Re: Responses to Barrier Wall and Groundwater Extraction System 90% Design Report, Chemours Fayetteville Works, Fayetteville, NC

**NC DEQ CONDITIONS FOR CHEMOURS
90% DESIGN OF BARRIER WALL SYSTEM**

**Hydraulic Head Evaluation Network
for Groundwater Remedy**
Chemours Fayetteville Works, North Carolina

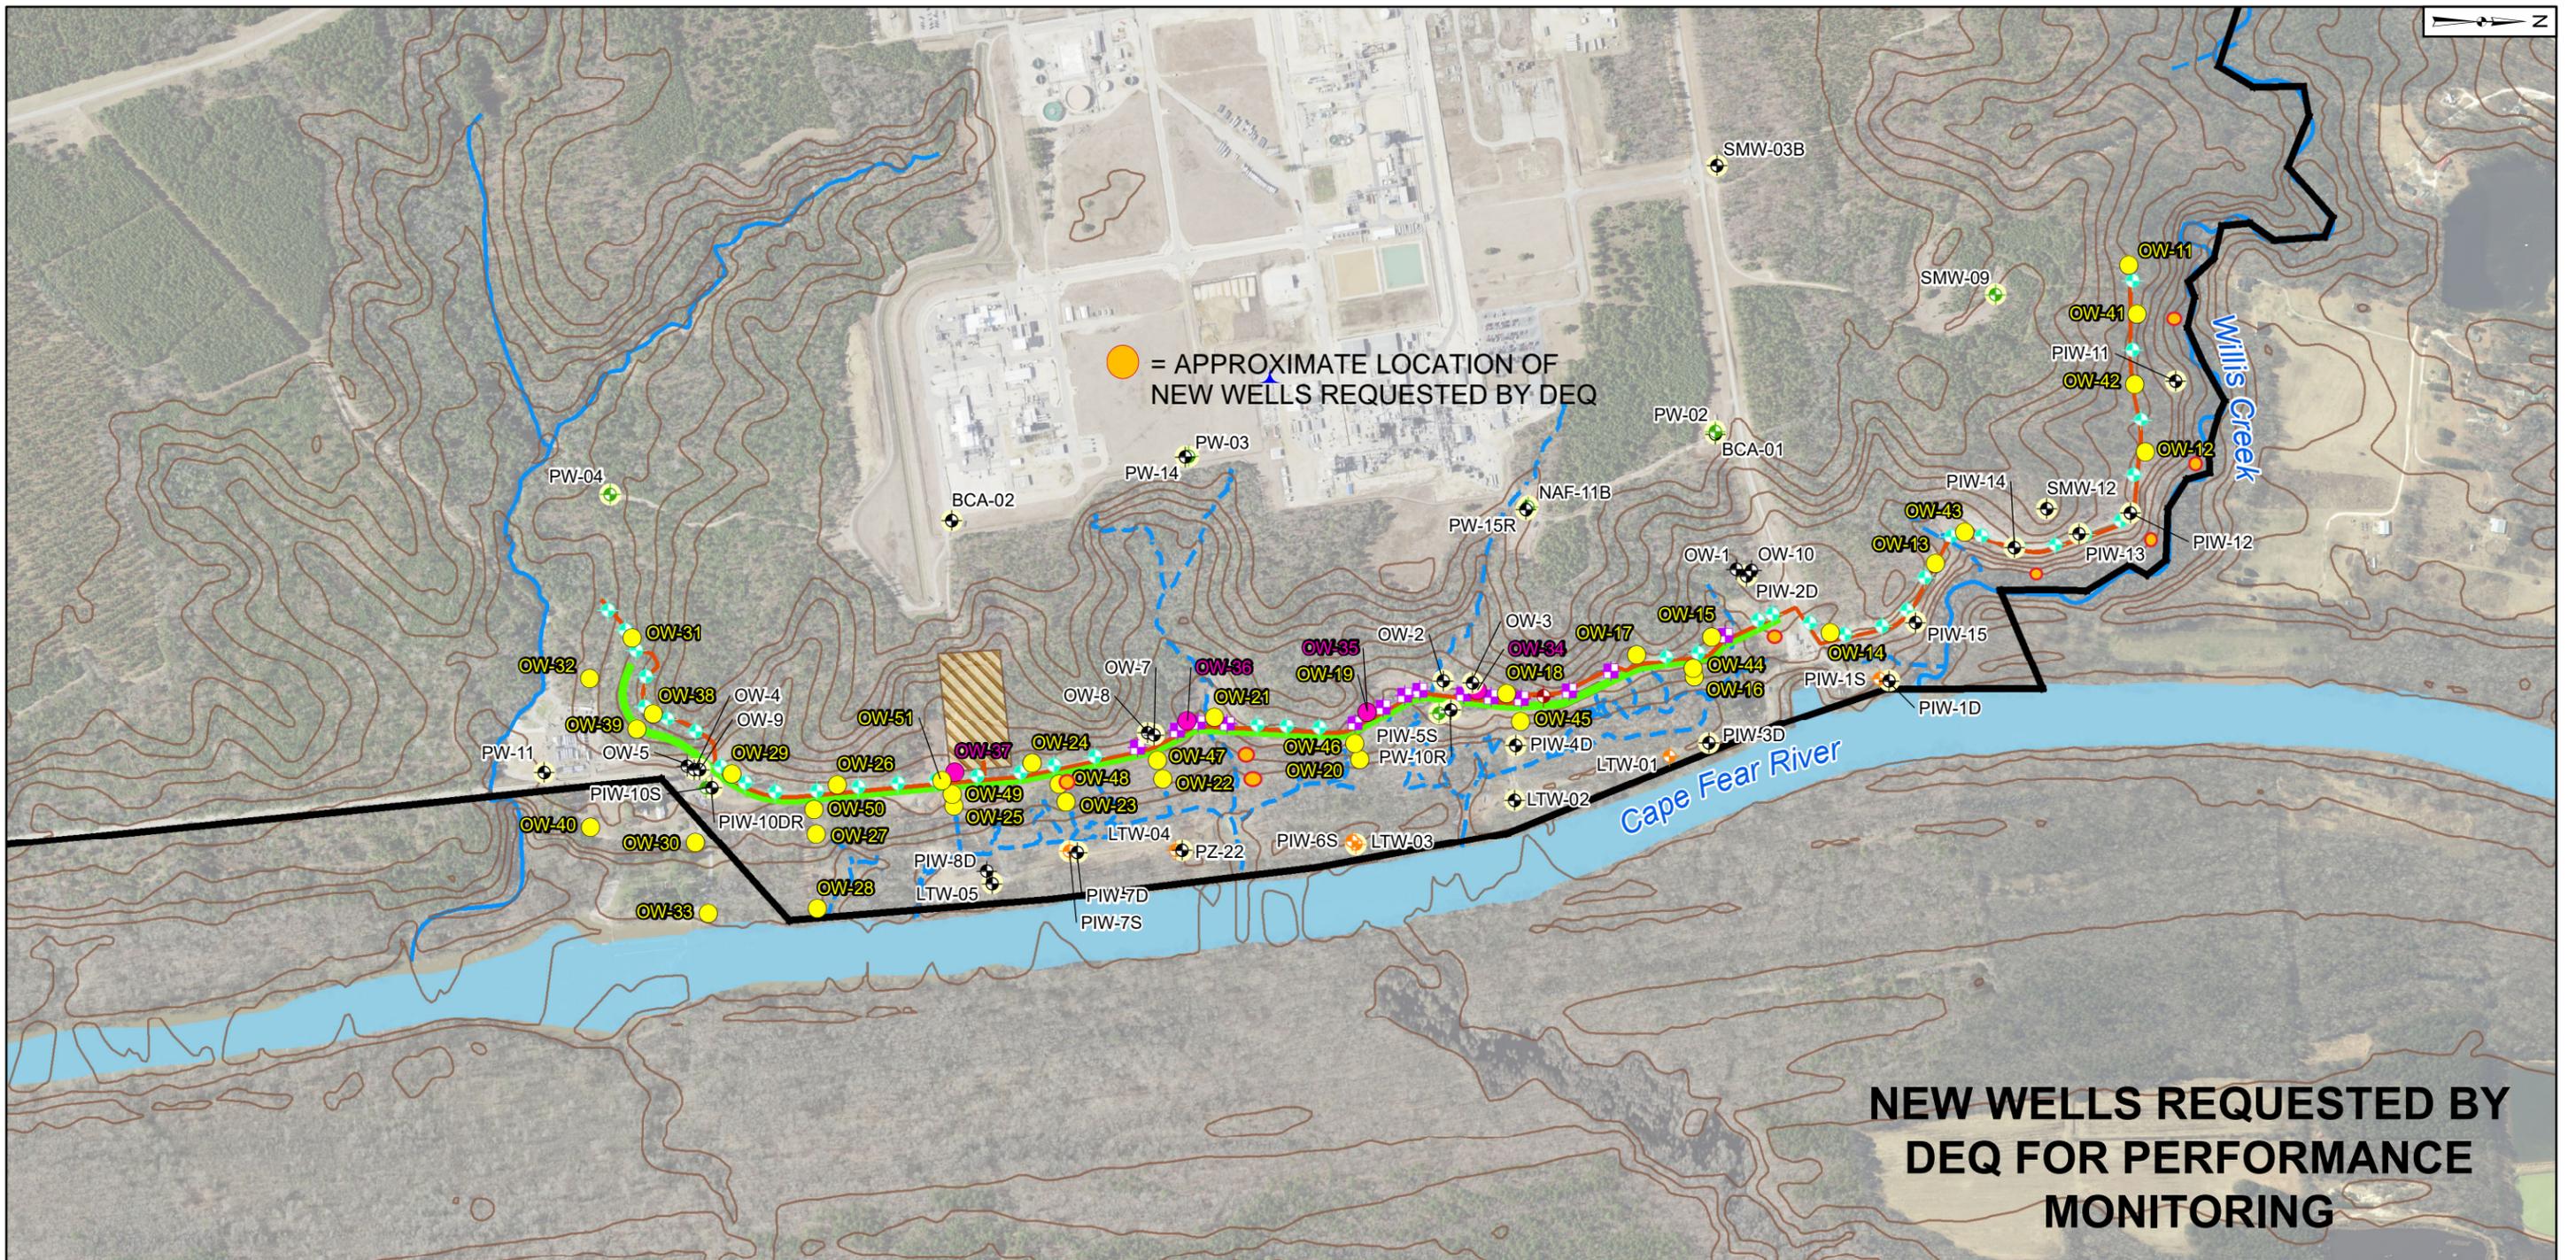
1. Installation of additional monitoring wells: Within 120 days and in consultation with DEQ, Chemours shall install nine (9) additional groundwater monitoring wells near Willis Creek and on the downgradient side of the barrier wall at locations approved by DEQ:

- a. Four (4) shallow observation wells shall be installed adjacent to Willis Creek to augment data from PIWs-12-15 using either a small footprint tracked drill rig or hand auger.
- b. Five (5) additional observation and monitoring wells shall be installed on the downgradient side of the barrier wall to monitor the Surficial and Black Creek (BC) Aquifers. Three of the five additional wells are requested along the Seep B tributary between the barrier wall and the floodplain. A nested piezometer (surficial aquifer well “A” and BC Aquifer well “B”) is requested on the north side of the tributary between OW-46 and OW-47. A BC aquifer well “C” is requested between OW-20 and OW-22. Two additional surficial aquifer wells are requested near and downgradient of the wall equidistant between OW-14 and OW-44 (well “D”) and paired with deep BC aquifer well OW-48 (well “E”).

● = APPROXIMATE LOCATION OF NEW WELLS REQUESTED BY DEQ

NEW WELLS REQUESTED BY DEQ FOR PERFORMANCE MONITORING

Passive Flux Meter Deployment Plan
Chemours Fayetteville Works, North Carolina

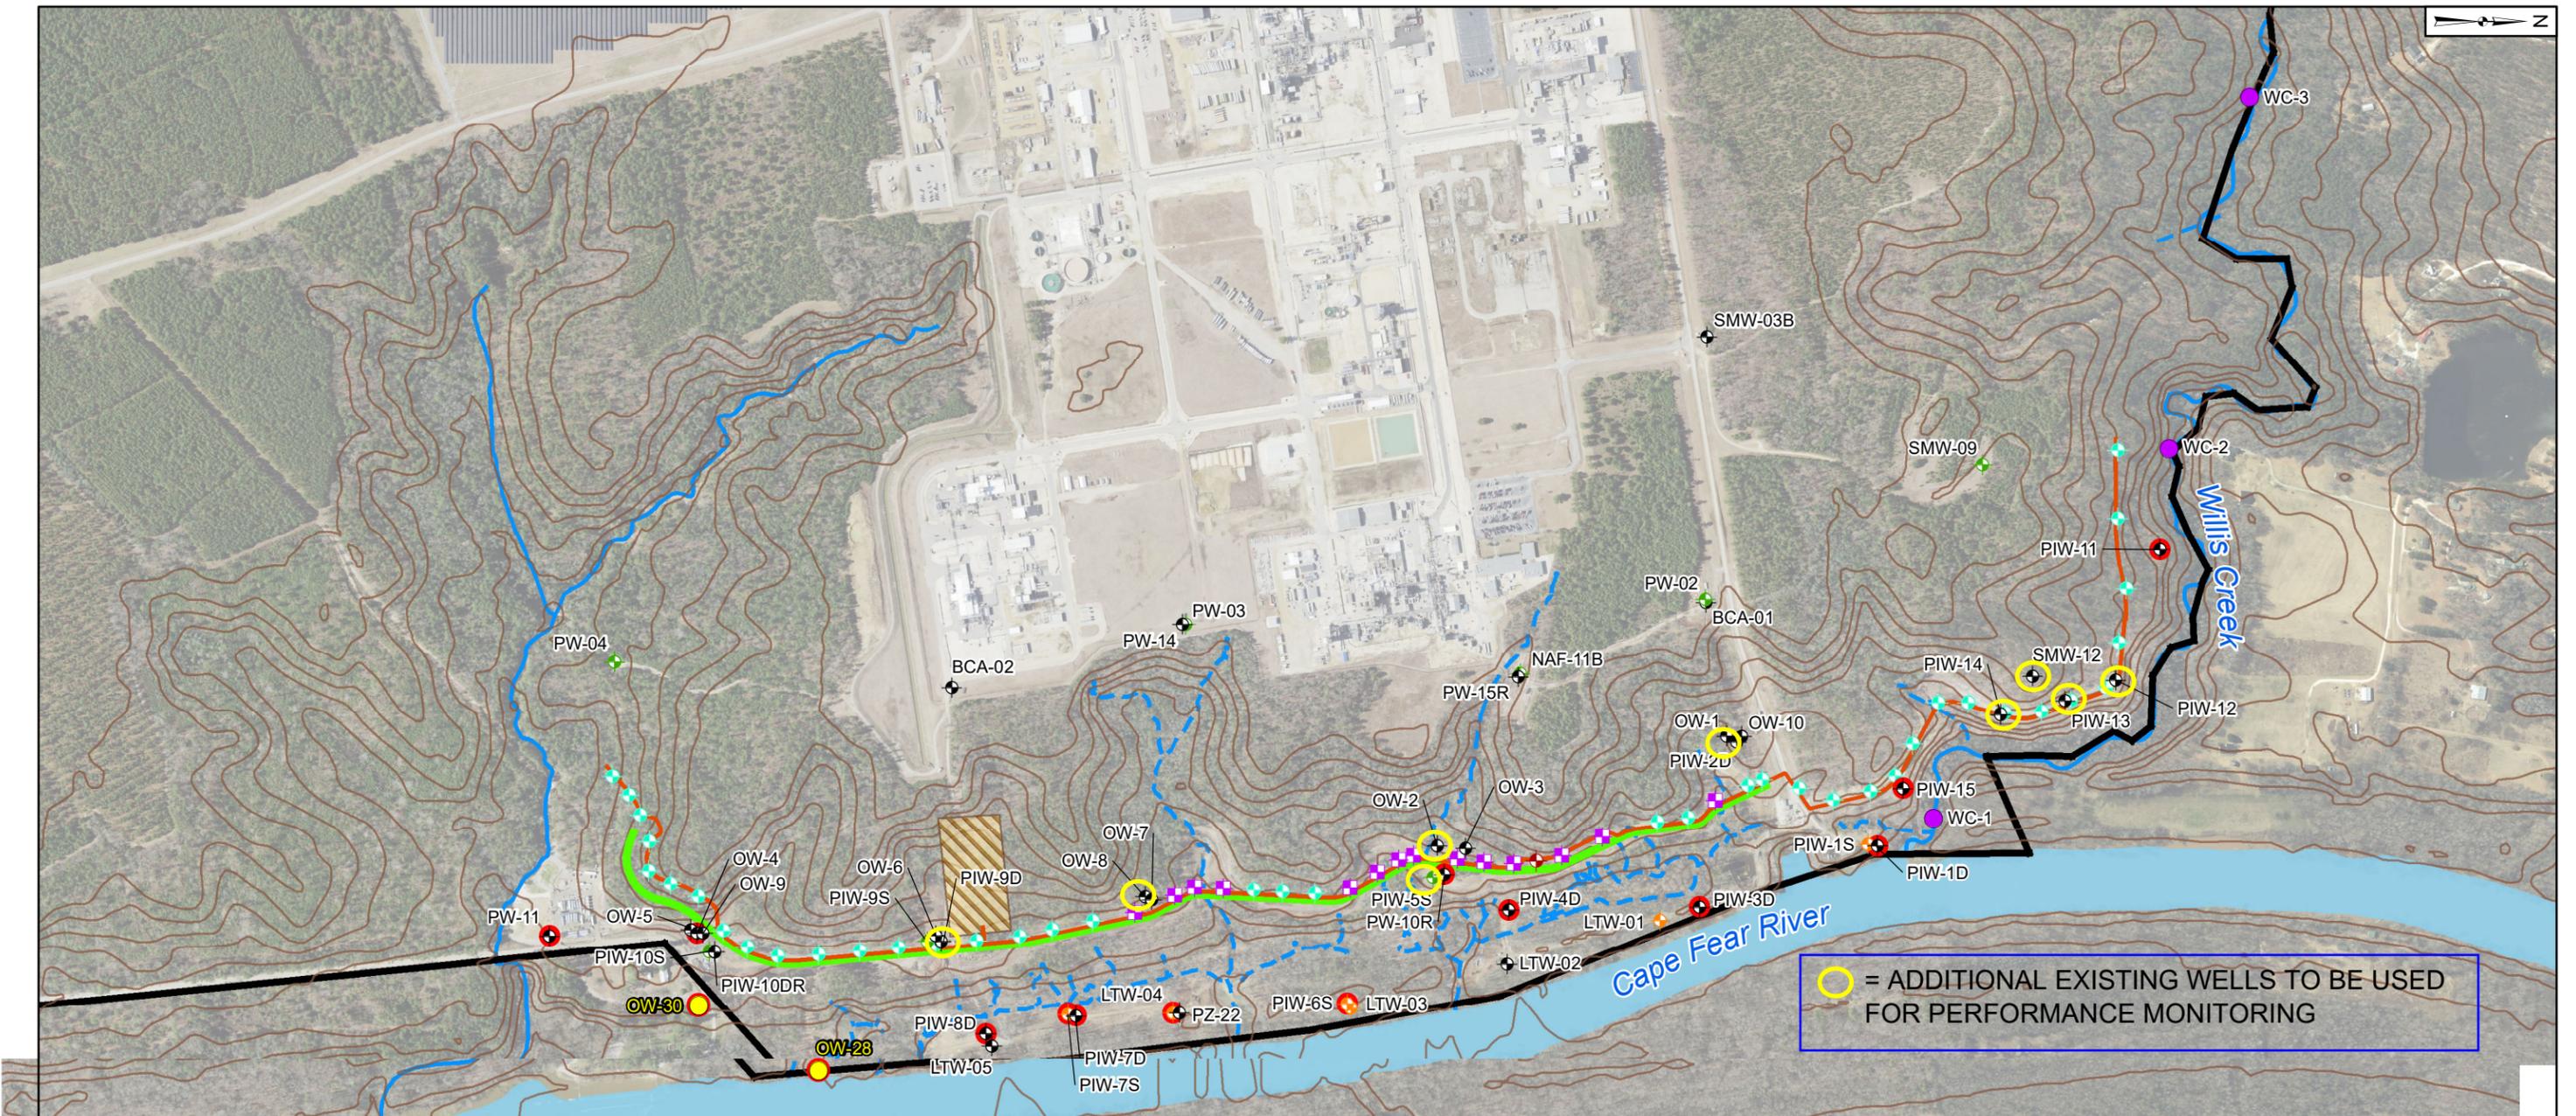
- 4. Use of Passive Flux Meters Not Approved:** The use of Passive Flux Meters (PFMs) for measuring the mass flux of Table 3+ PFAS compounds in the PMP is not approved at this time. The efficacy of the PFM method for measuring Table 3+ PFAS unique to the Chemours site has not been demonstrated, particularly related to the capability of the PFM resin to sorb certain short chain Table 3+ compounds and the extraction capability of current laboratory procedures for those PFAS collected in the resin. Traditional groundwater sampling of PFAS shall be conducted for purposes of performance monitoring. Though not required, Chemours may continue to deploy PFMs to evaluate their efficacy and for comparisons with other performance monitoring measures.
